APPEAL SUMMARY

Appeal ID: 22153	Project Address: 601 SW 11th Ave
Hearing Date: 11/20/19	Appellant Name: Brian Cobb
Case No.: B-015	Appellant Phone: 503-445-7322
Appeal Type: Building	Plans Examiner/Inspector: Catherine Heeb
Project Type: commercial	Stories: 15 Occupancy: R1, A2, A3, B, S1 Construction Type: I-A
Building/Business Name: Hyatt Centric Portland	Fire Sprinklers: Yes - Throughout
Appeal Involves: Reconsideration of appeal	LUR or Permit Application No.: 17-279972-CO
Plan Submitted Option: pdf [File 1]	Proposed use: Hotel

Appeal item 1

Code Section 3007.4

4th-14th Floor Fire Protection

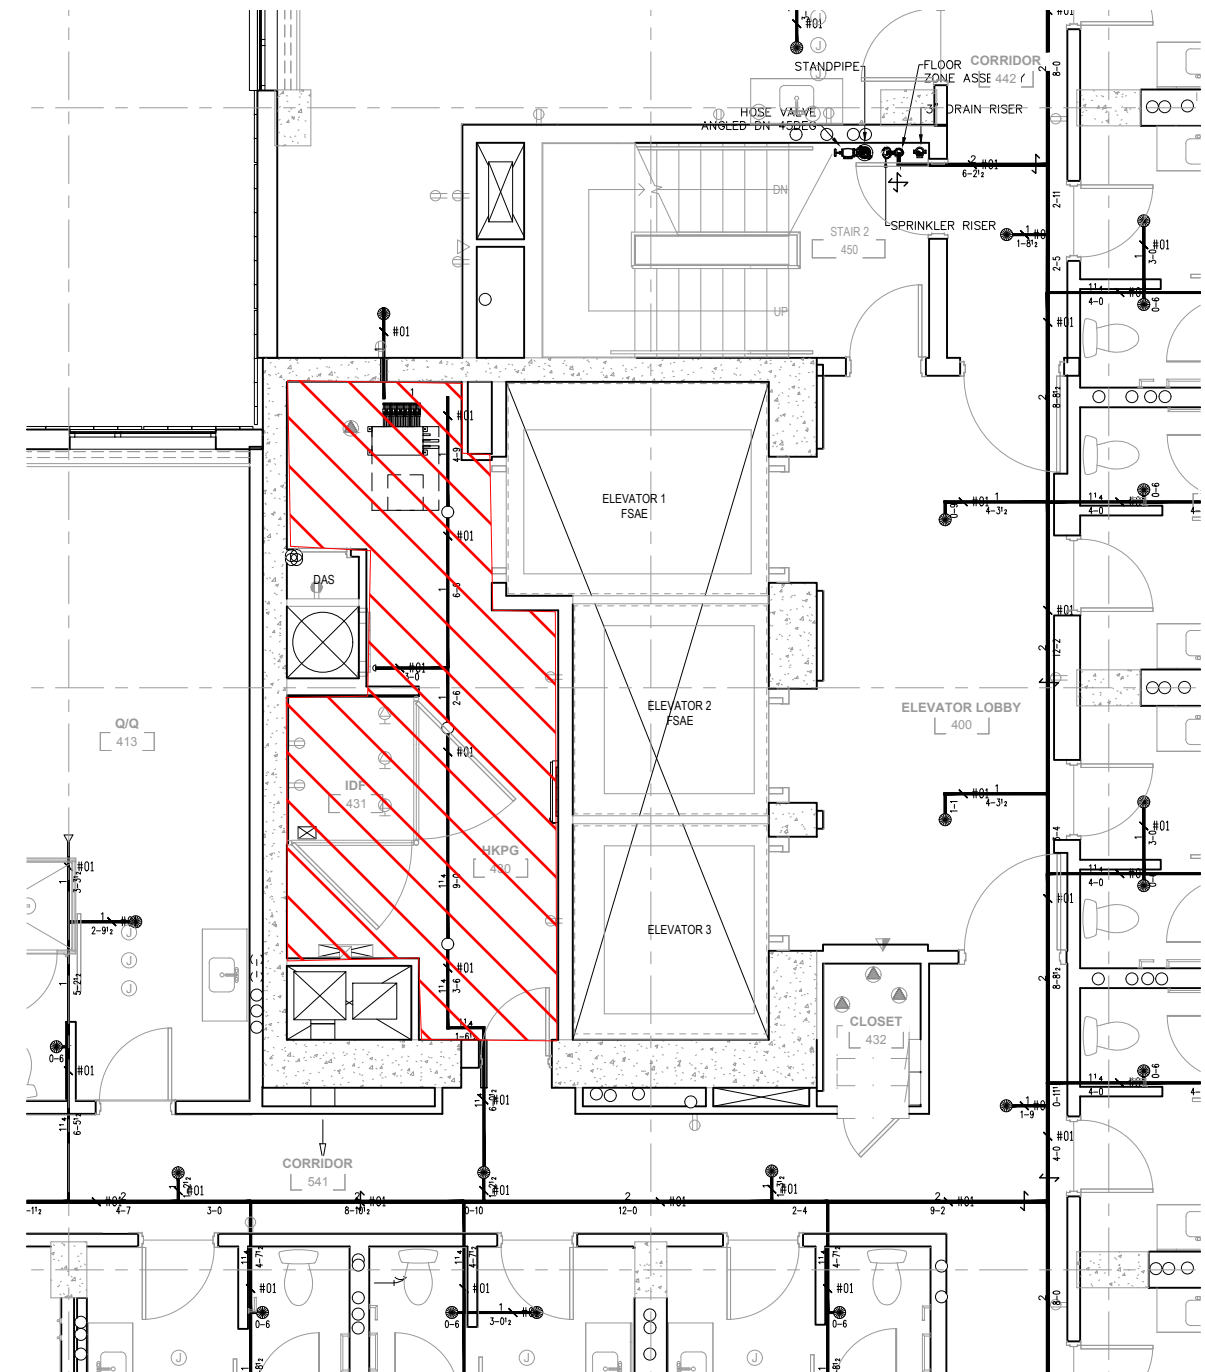
FSAE Car 1, front/rear opng, opens to sprinkled "back of house" areas which would not be exempt from water protection requirements of the hoistway as the FSAE lobby at the front would.

Proposed design would treat the rear housekeeping area, for purposes of water protection, like the FSAE lobby and keep sprinkler water from outside the space from infiltrating the hoistway but exempt the sprinklers within the housekeeping area.

We believe, based on these factors, that exempting sprinkler heads in the rear housekeeping area, i.e. space directly accessible to the rear car door, while preventing additional water from entering the space would provide a viable FSAE system to the greatest extent possible for this configuration.

Fire Service Access Elevator hoistway sprinkler water infiltration: Granted as proposed.
